ON-SITE SEWAGE DISPOSAL SYSTEM HOWARD COUNTY HEALTH DEPARTMENT BUREAU OF ENVIRONMENTAL HEALTH

SUBDIVISION: Pindell Woods LOT NUMBER: 20

ADDRESS: 7216 Preservation Court PROPERTY OWNER: Dale Thompson Builders

TITLE:
WALL CHECK

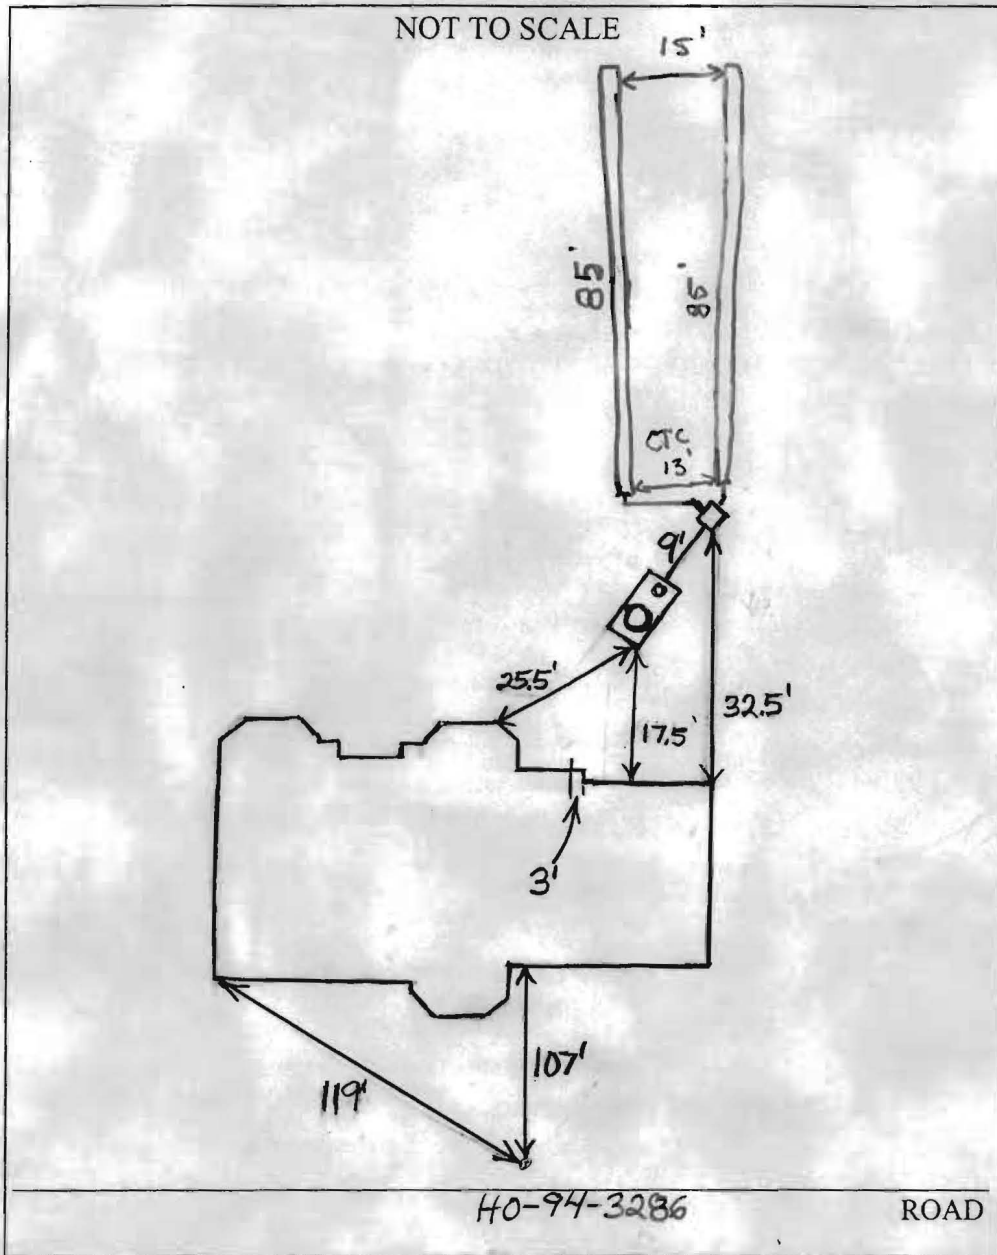
TRENCHES:	Trench to be 3.0 feet wide. Inlet 4.0 feet below original grade. Bottom maximum depth 7.0 feet below original grade. Effective area begins at 4.0 feet below original grade. 3.0 feet of stone below distribution pipe.
LOCATION:	Place the distribution box as shown on the approved building permit plan. Maximize length of SDA in contour, run (2) 85' long trenches 12' center to center.
	Basement service is not proposed. <i>DURING LAYOUT, PUNCH 1 MORE HOLE ON WEST SIDE OF LOT IN SDA, ADJ. SDA 20' FROM HOUSE, CURRENTLY 18'</i>

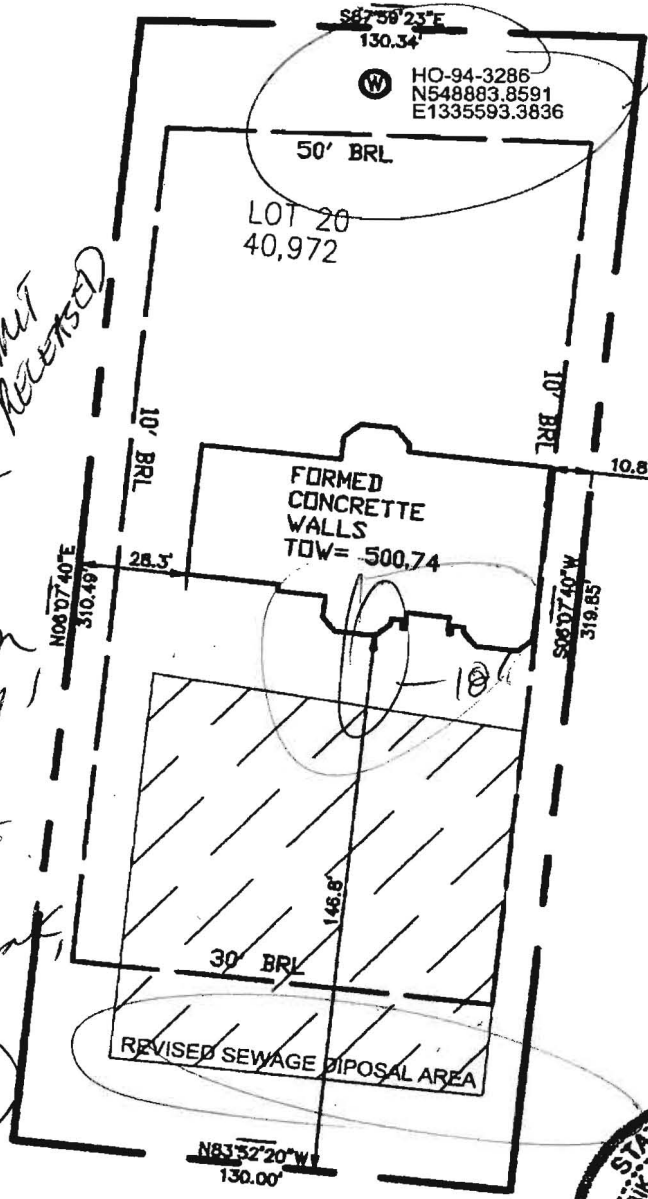
PRE-CONSTRUCTION 6/30/06 Fill is covering a large amount of the septic easement. Some fill (up to 1 foot) is located near INSTALLATION the top part of the easement that is closest to the house. O.K. to install 2 - 85' trenches across the top of the easement towards the court. Keep trenches within 6" of original contour. Builder must delicately have fill removed from the septic easement. Perc test hole dug and visualized BB

6/28/06 ATTORNEY
Need to adjust OKD
SDA - NOT PERMIT REVERSED
20' from foundation
only 18'
SDA supposed by
READ'S BEFORE
ENSURE 20' from
house to S. tank,
ALSO KN

7/5/06 Trenches installed and ok to cover. GAC
